ADDENDUM

Forestside Estates
Attmar & Palleschi Drive
Brampton, Ontario
Attn: **Vince Staffieri**

AM 08

PROJECT	**: Forestside**
PROJECT #	**: 1331.15**
DATE	**: Jan 18, 2021**

THIRD FLOOR OVERALL PLAN

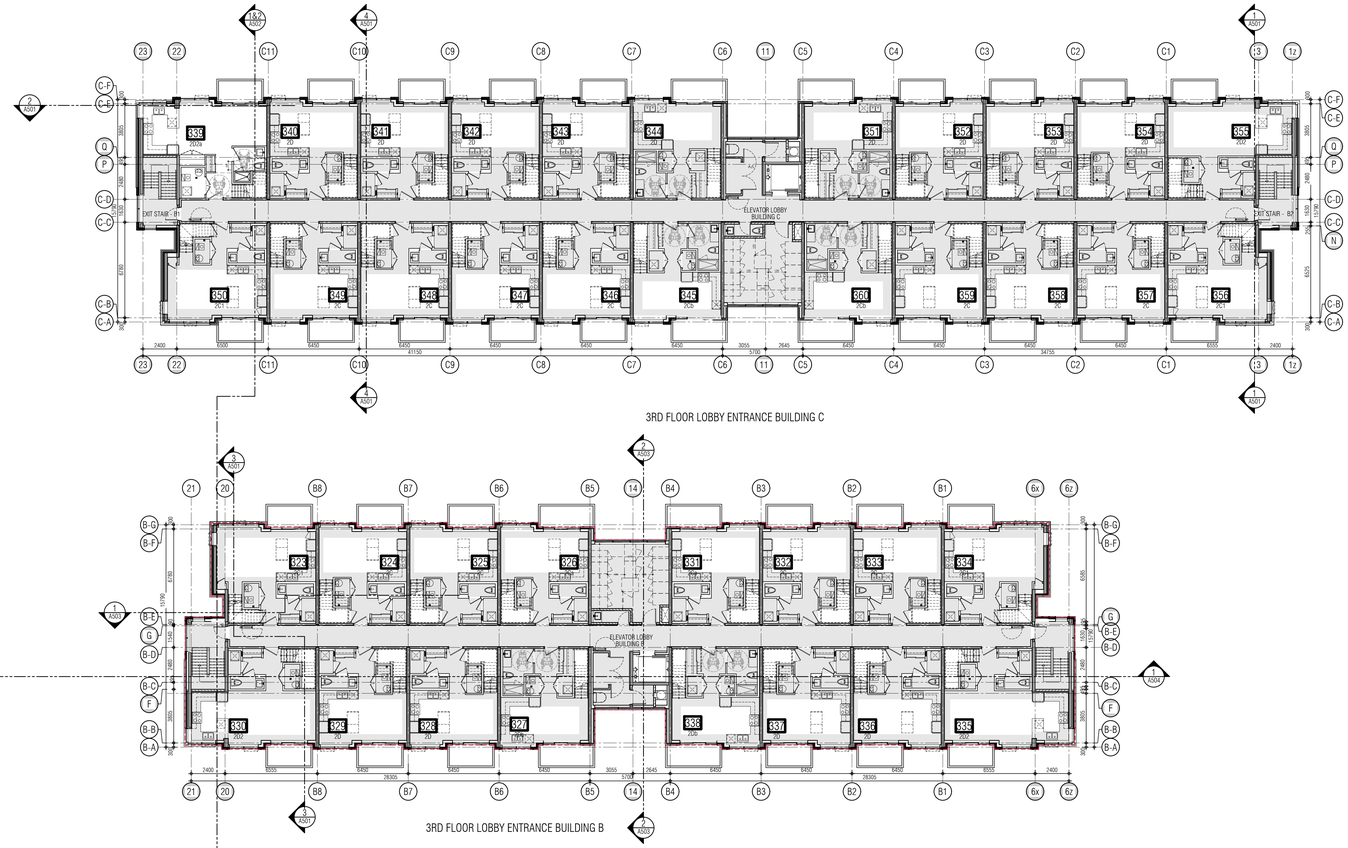
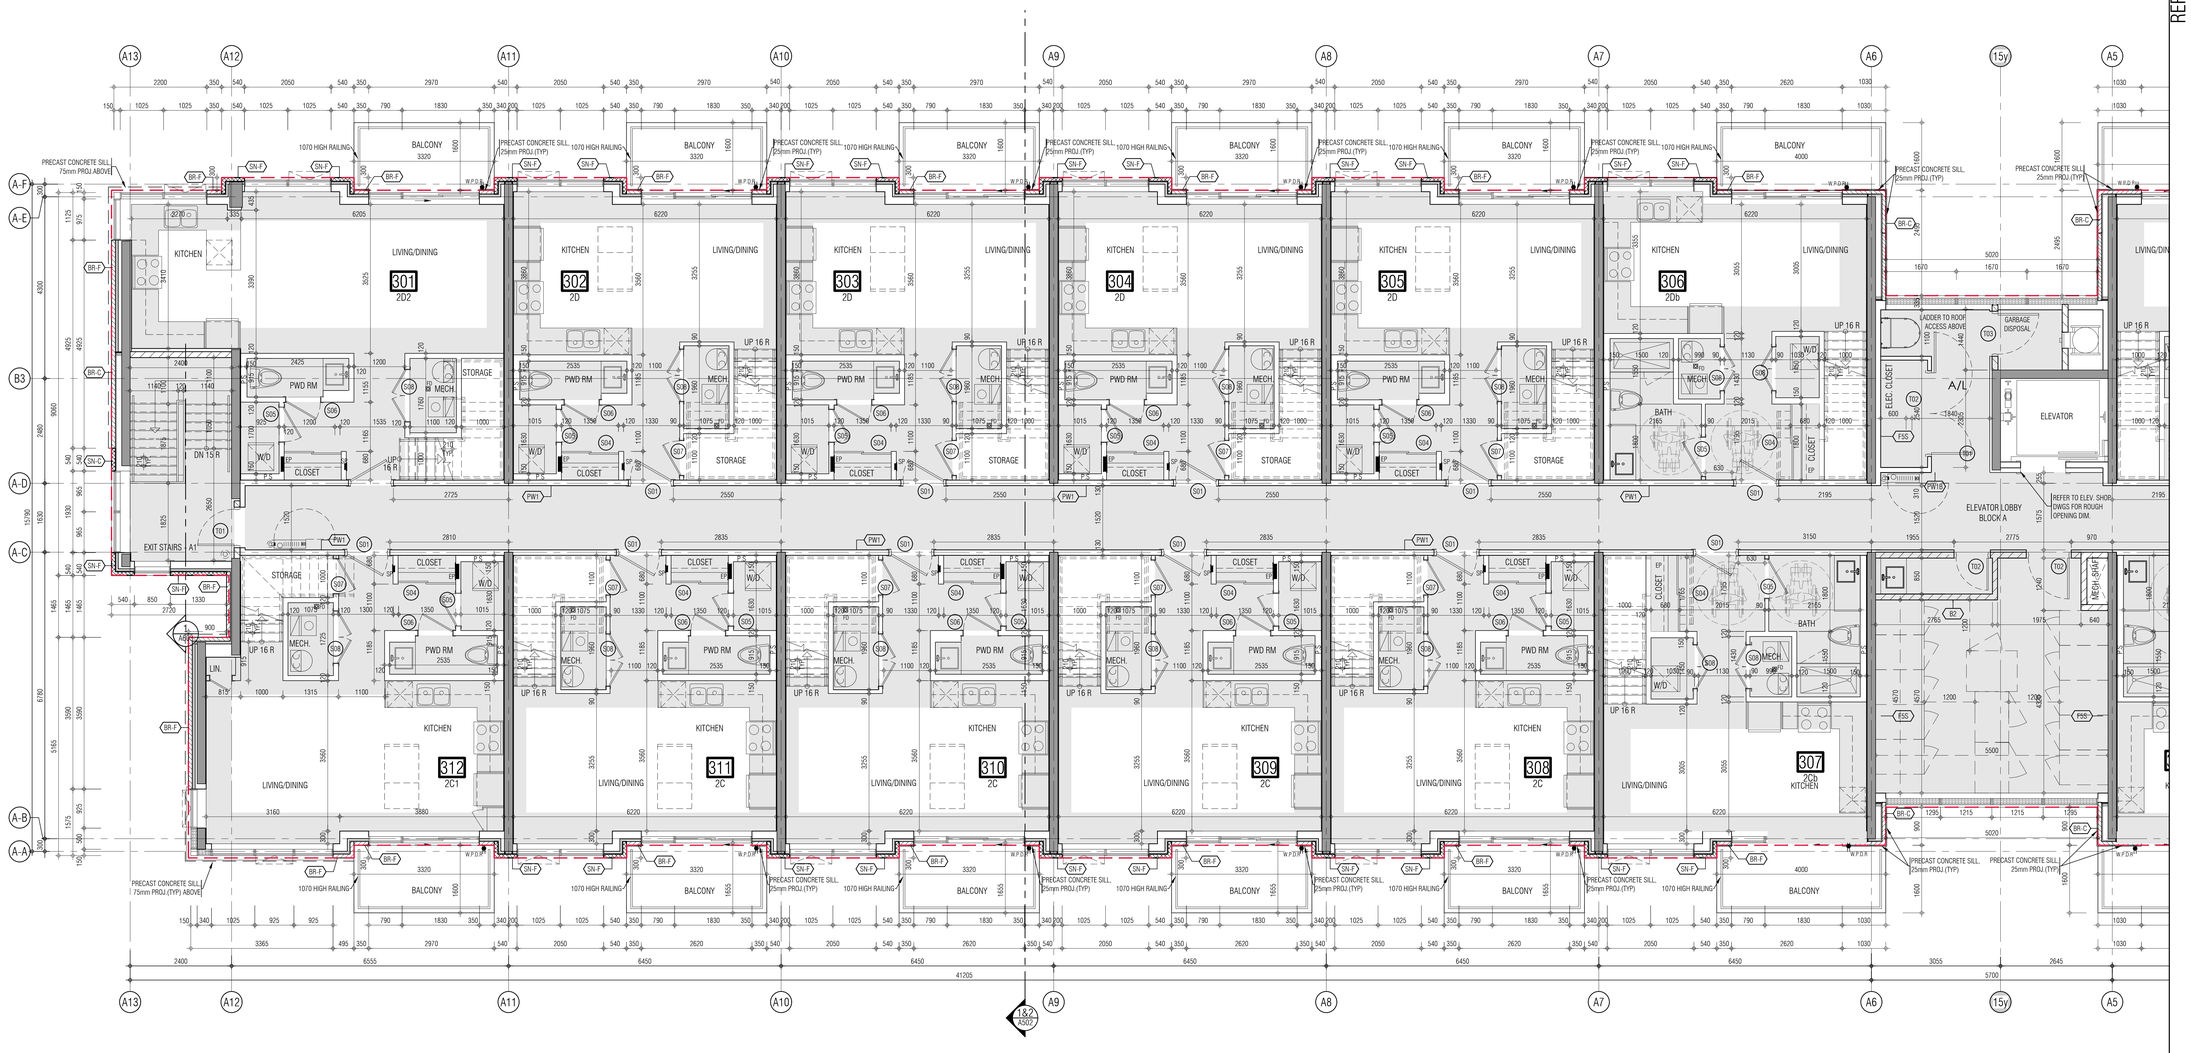
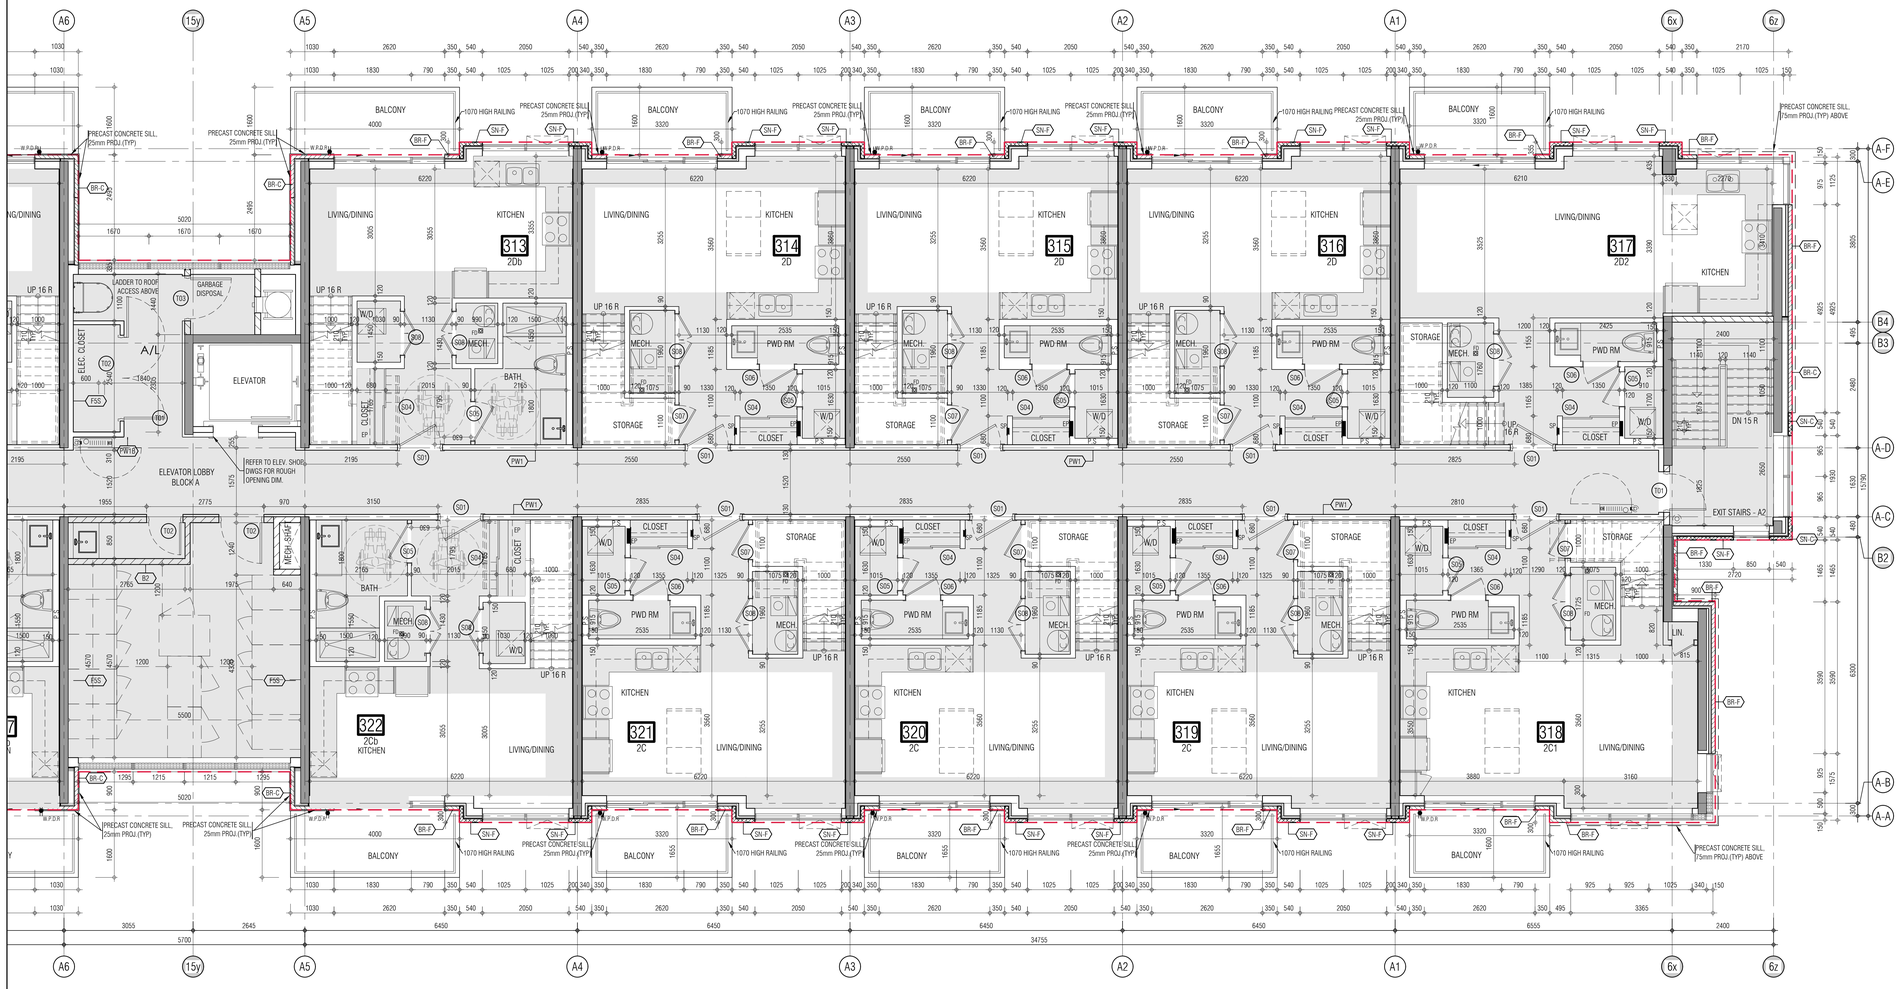
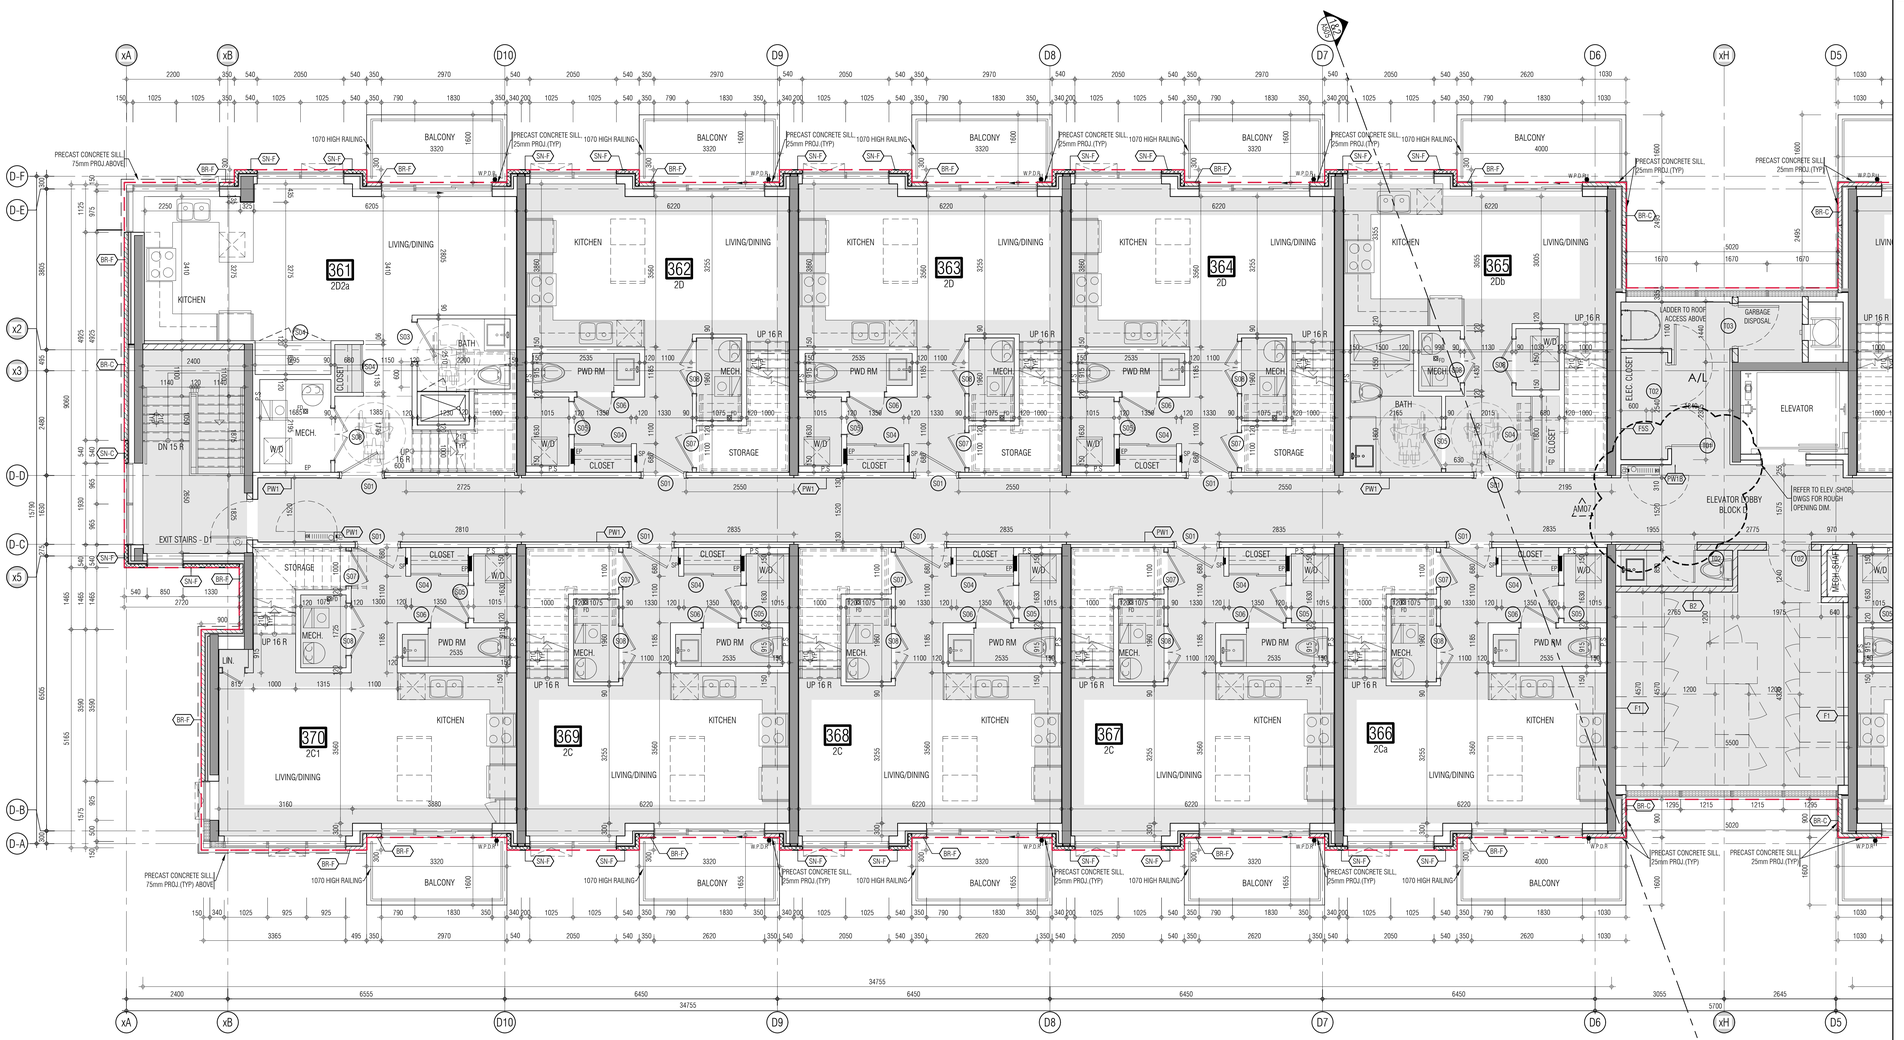
A301-A304	1st – 4th Floor Plans	• Move Blocks A and B north 286mm to comply with 0.3m easement and 3.0m minimum set back to property line as per clients request. • Move Block D up 390mm along angle north to comply with 0.3m easement and 3.0m minimum set back to property line as per clients request.
A701a-A701b	Stair Sections	• Revised dimensions on stair plans to match blocks that were moved.
